## PLANNING COMMISSION MEETING

**RE: Ginko Self Storage -Final Site Plan/Final Engineering Plan Review-3<sup>rd</sup> Review  
Stormwater Maintenance Agreement Review-1<sup>st</sup> Review**

## Revised Final Site Plan Review for Special Land Use for White Lake Charter Township, Michigan

# GINKO SELF STORAGE

**BUILDING #3 - SOUTH ELEVATION**  
 SCALE : 1" = 10'

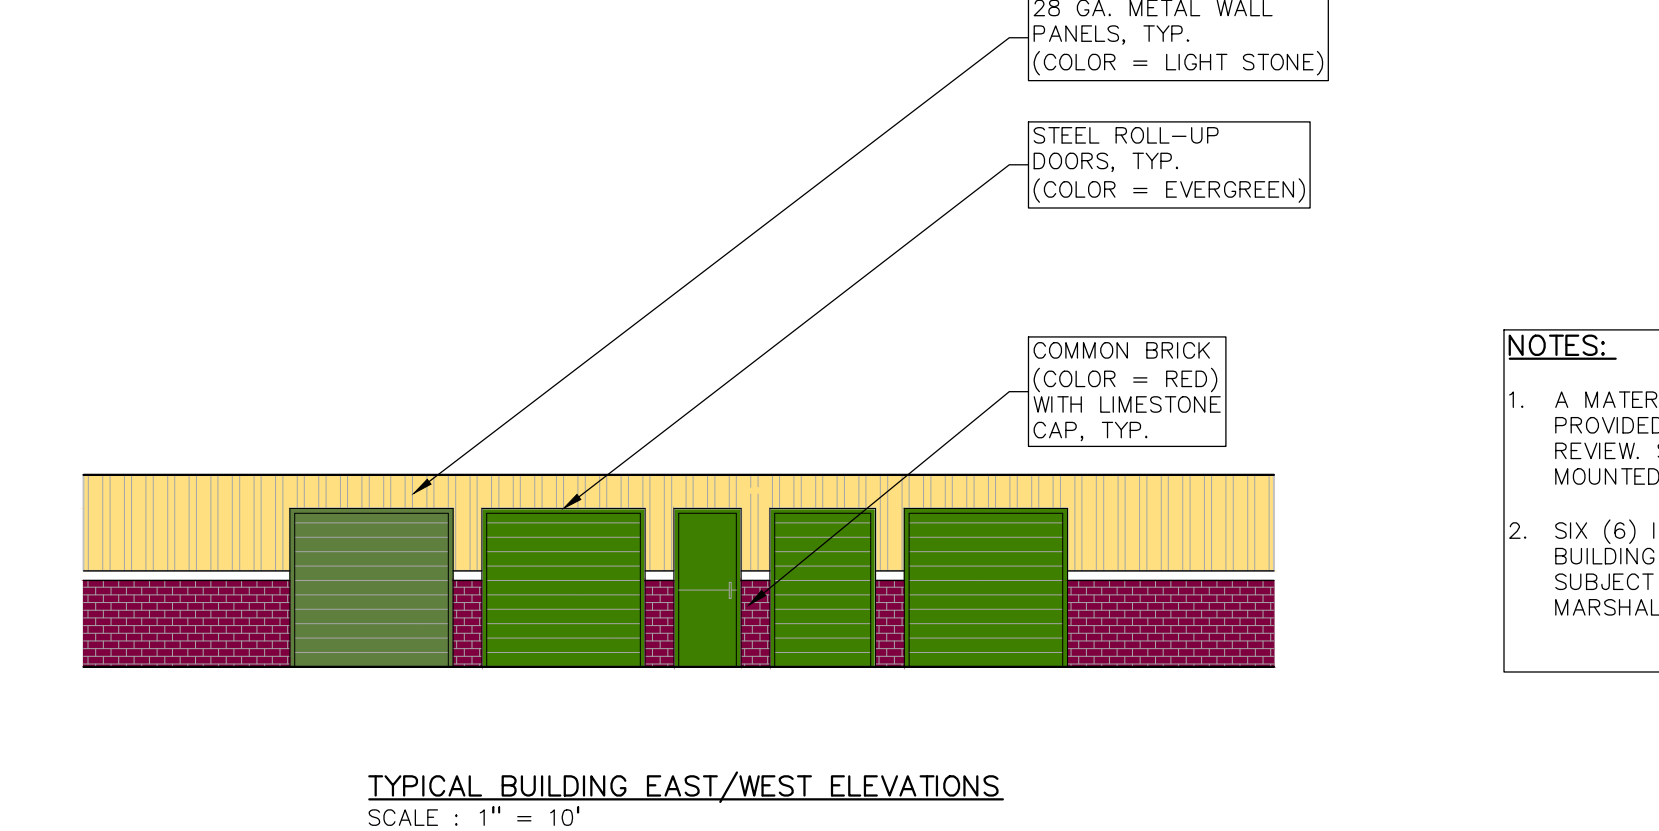
Architectural information required at final site plan review includes the types of facing materials to be used on structures. Sheet A-1.0 indicates all elevations will be faced with metal panels, steel roll up doors, and common brick with limestone caps. The sheet provides a note stating *“A material sample board shall be provided for the Planning Commission review. Colored elevations shall be provided as part of the final site plan review”*. Colored elevations are included in the final stie plan.

**Items to be Addressed:** *1.) Exterior construction material sample boards and colored elevations shall be provided for Building Official and Planning Commission review. Comment remains as a notation. 2.) Roofing materials and colors should be shown on color elevations as well as Sheet A-1.0. Addressed.*
